Subject: FW: Stakers Farm

PROJECT
BARN5 AT STAKERS FARM
NORTH END ROAD
YAPTON BN18 0DU

DRAWING TITLE
PROPOSED SITE LAYOUT

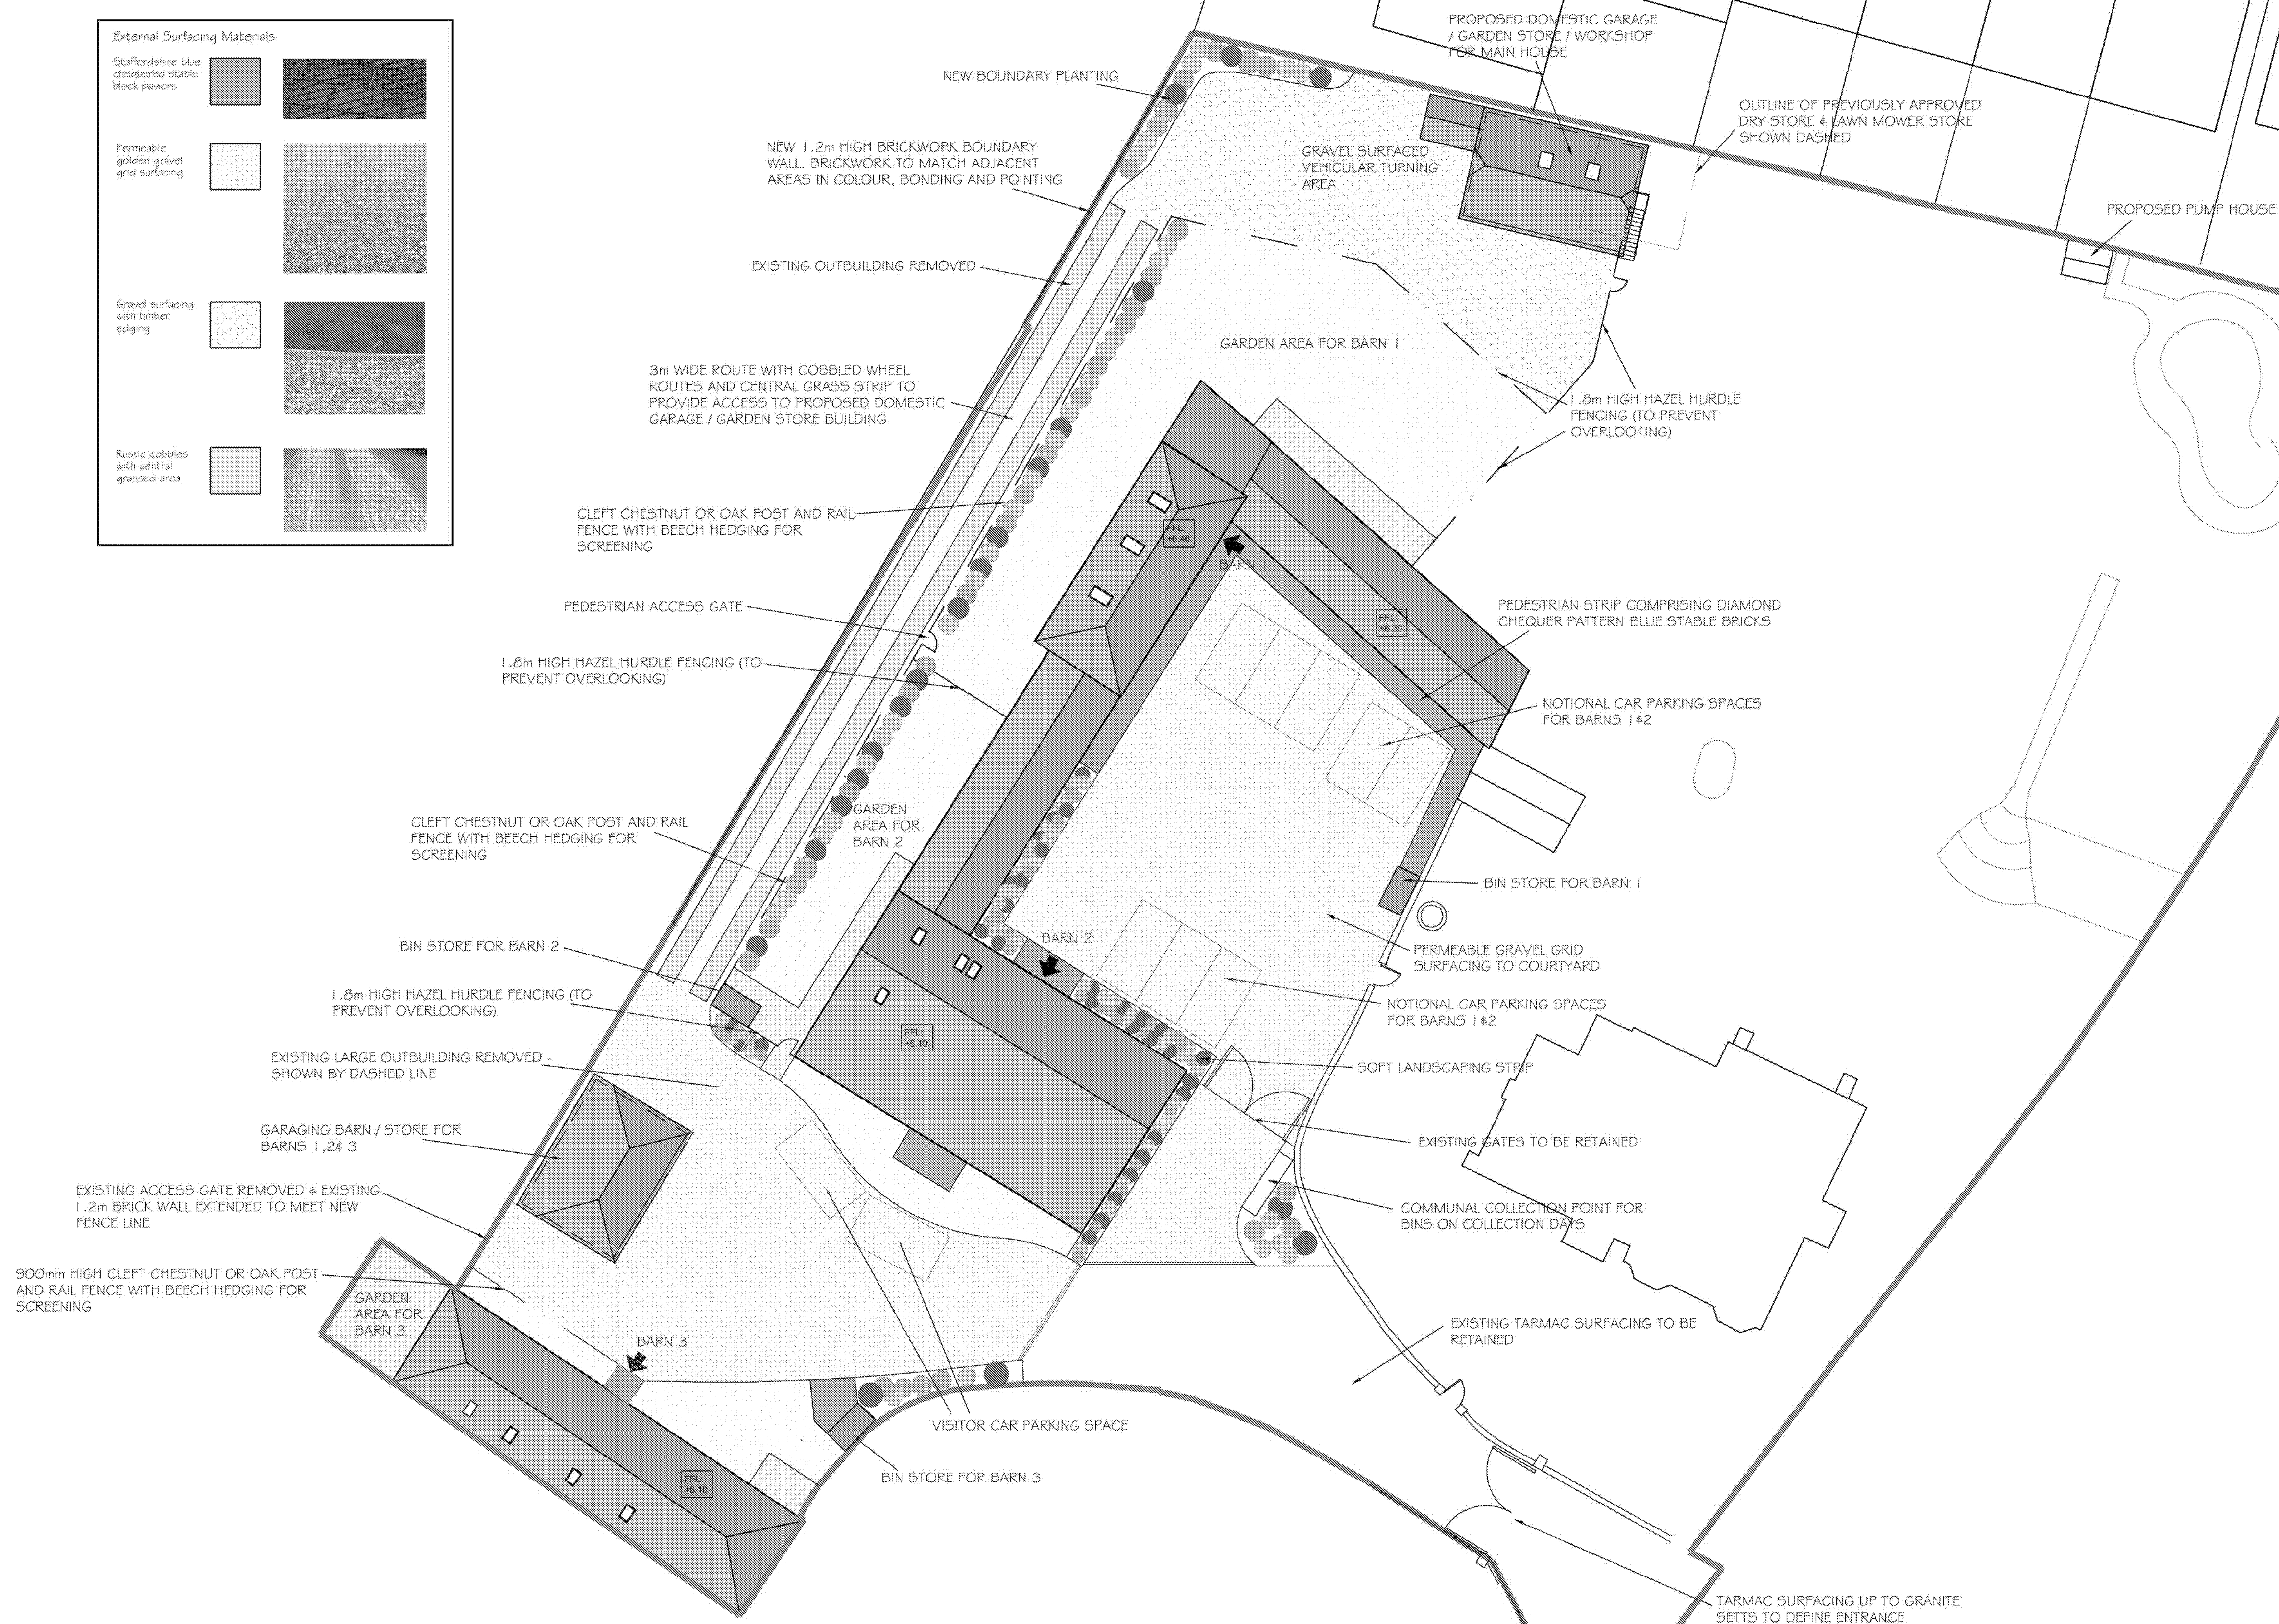
- Surfacing materials for the access and parking areas – we have changed the previously proposed brick paviors within the parking areas to permeable gravel laid within a grid system with blue stable bricks for the pedestrian areas.
